SUBJECT: Notice of Appeal, DNS decision dated May 14, 2024
8229 – Talbot Road, Edmonds, WA
Continued Maintenance of Fish-Killing Flow Splitter
File No.: PLN2024-0020

Attachment B: Lider Engineering PowerPoint, rev. March 24, 2024

Perrinville Creek
Failed Culverts and Flow
Splitter threaten BNSF Rail
Tracks,
Puget Sound
Edmonds, WA

Cross section of flow splitter from Preliminary, not for construction drawings dated July 1, 2010

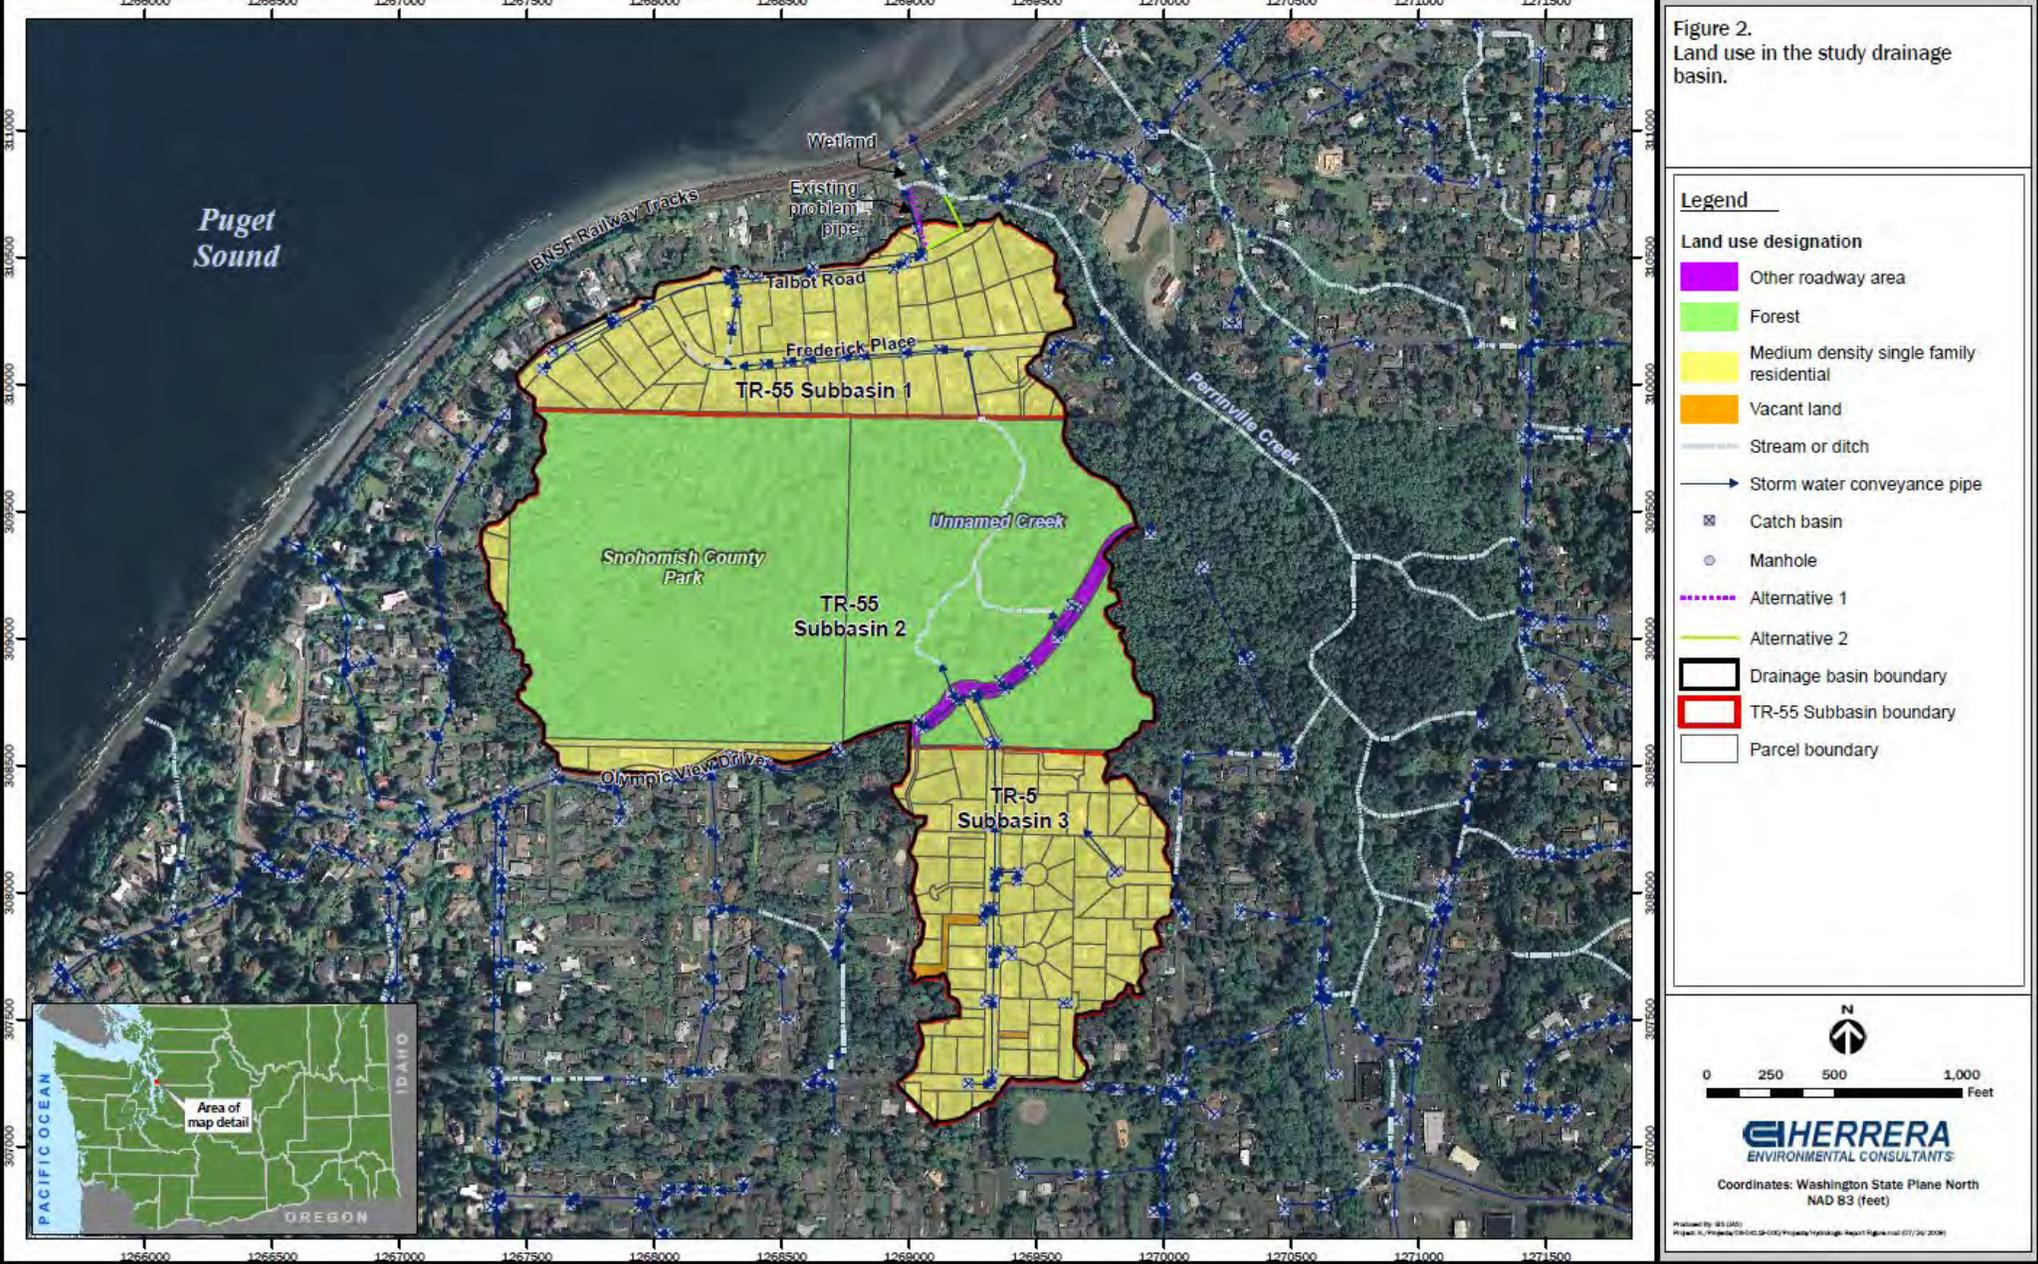
The 30" Culvert constructed in 2012 added 125.75 acres and 30.5-cfs additional flow from Talbot Road. The Hydraulics Code requires this design to prevent fish entry.

This outfall structure violates WAC 220-110-170 because it is not constructed according to an approved design to prevent the entry of fish.

In 2012, the City installed a 30-inch pipe from Talbot Road to the flow splitter, diverting even more flow under the BNSF tracks. The basin study or hydraulic calculations produced were inadequate and did not show that the pipes under the BNSF tracks could accommodate this additional flow or prevent fish entry.

Table 6. Flow frequencies for Perrinville Creek at Talbot Road culvert.

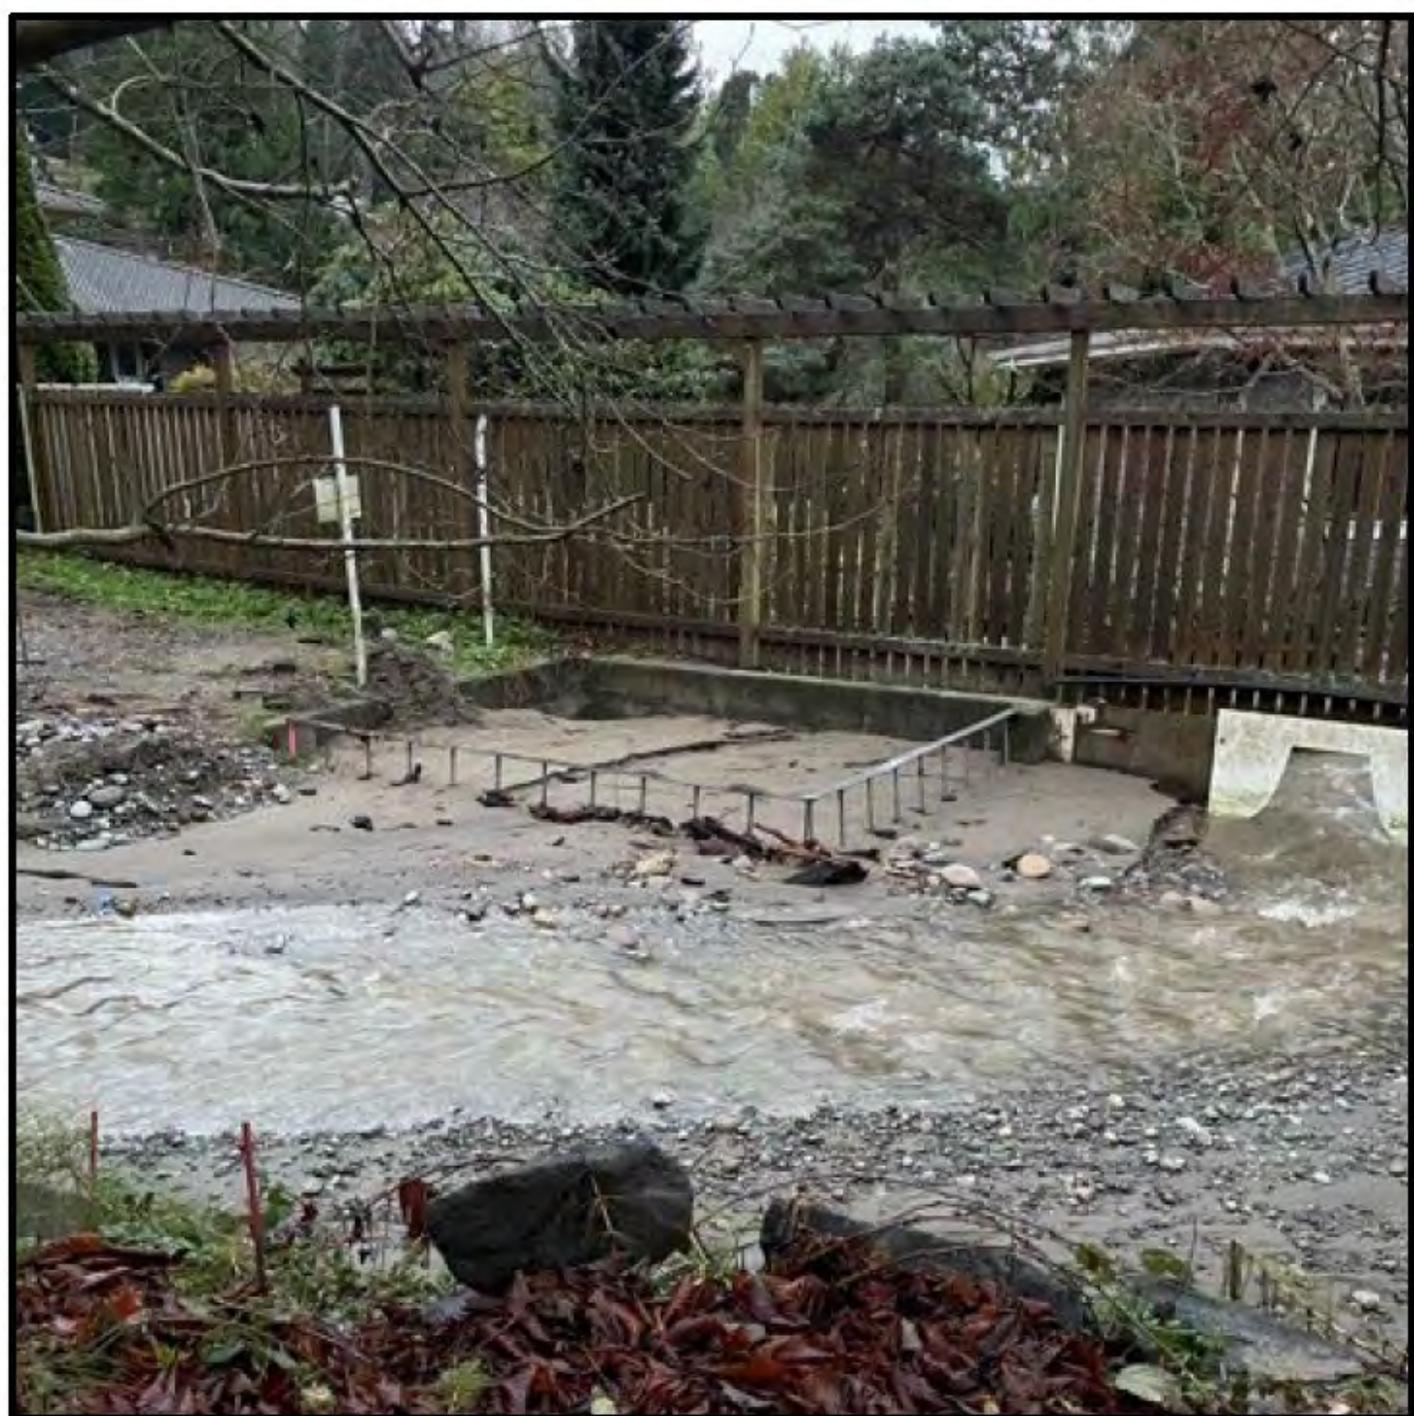
Pentec used calculations done by RW Beck in 1991, over 33-Years Ago!

225-cfs >> 33.3-cfs

Edmonds Public Works knew or should have known its high flow bypass pipe was undersized before installing the 30-inch pipe from Talbot Rd in 2012.

Per Herrera, the project flows in Perrinville Creek are estimated to be 225-cfs. Herrera relied on flow calculations done by RW Beck in 1991 using the U.S. Soil Conservation Service TR-20 computer model are likely low and need to be updated.

UNDERSIZED TALBOT ROAD CULVERT

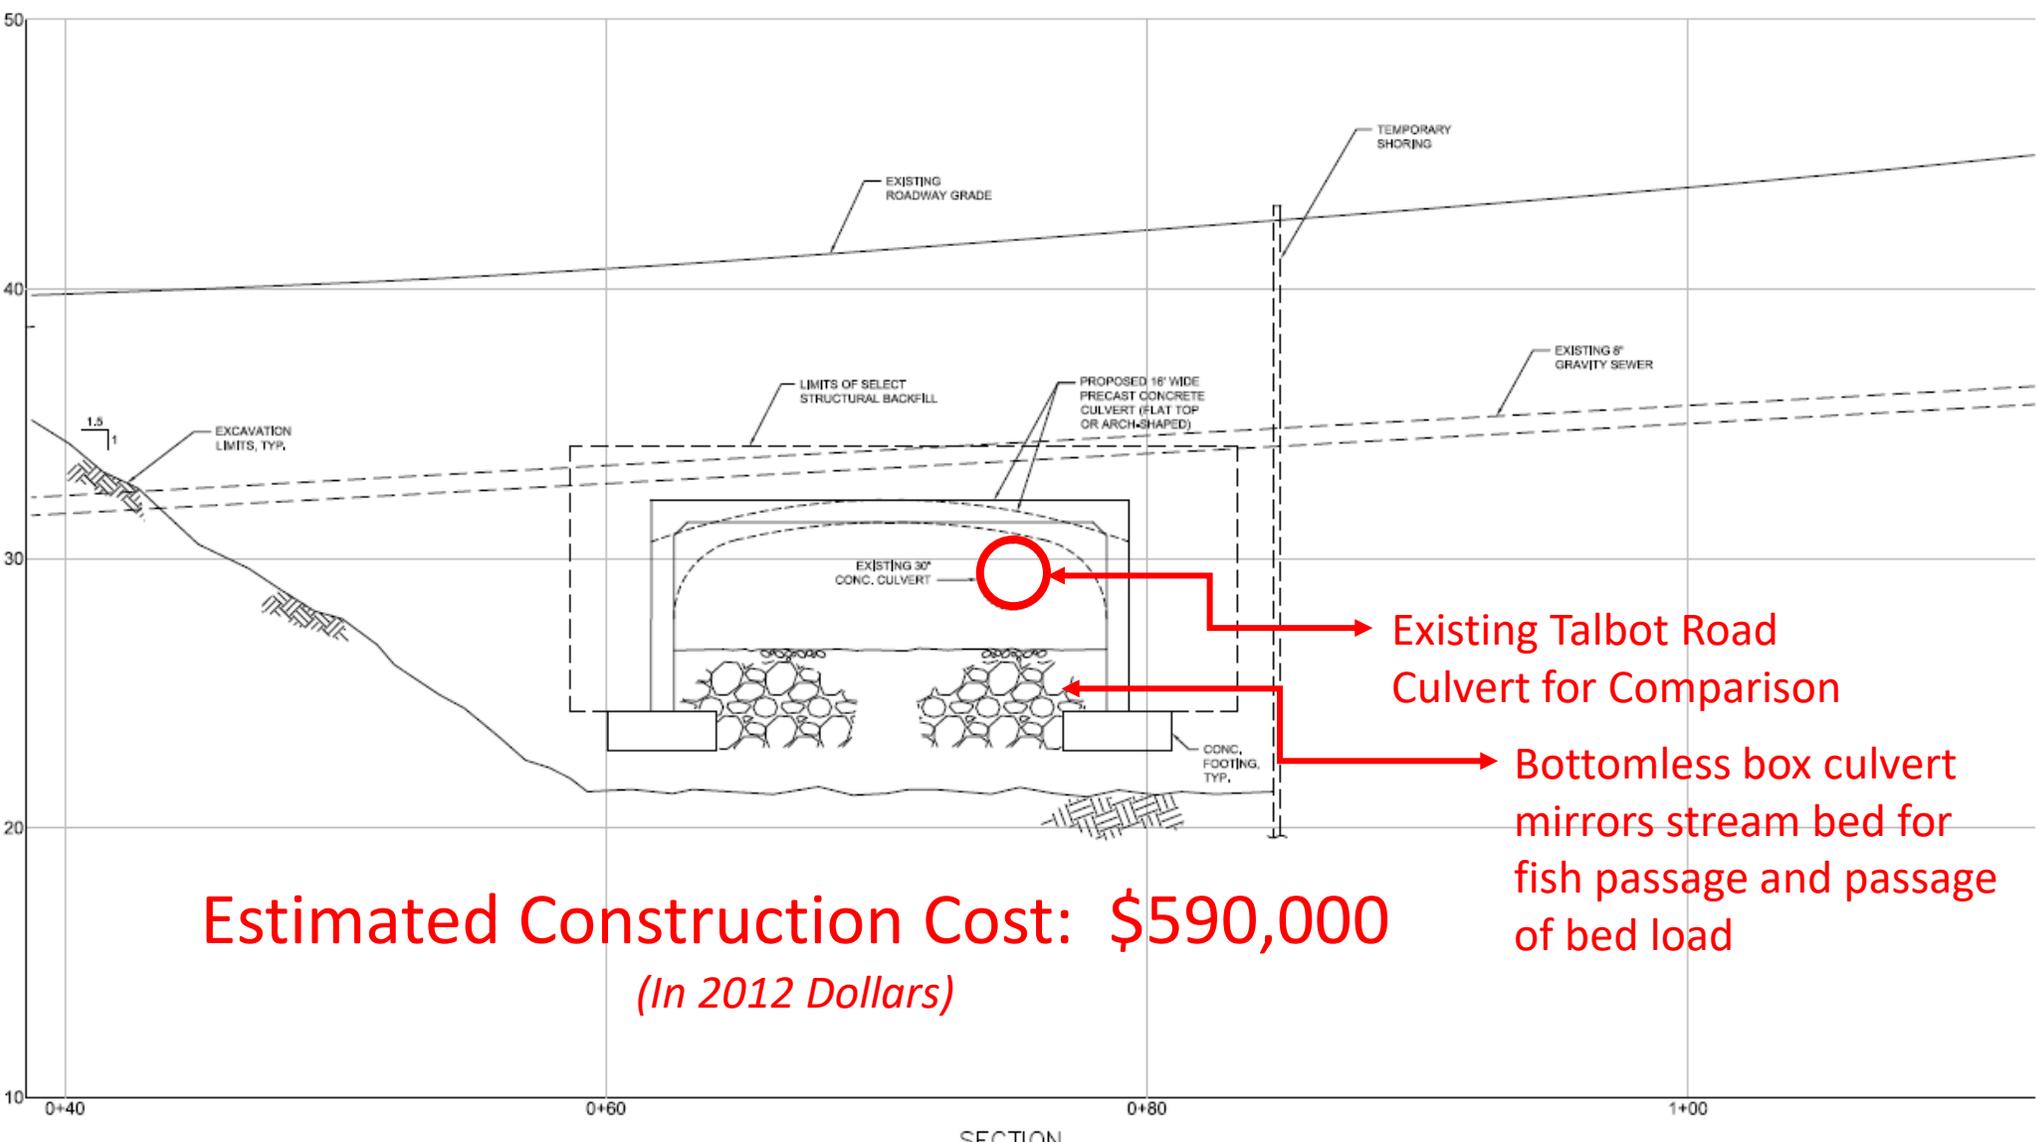
Talbot Road culvert overtopped by Perrinville Creek flow, December 21, 2020 with 1.98-inches of rainfall.

This is approximately a 5-year storm event (e.g. there is a 20% chance of this storm occurring in any given year).

Bottomless box culvert mirrors stream bed for fish passage and passage of bed load
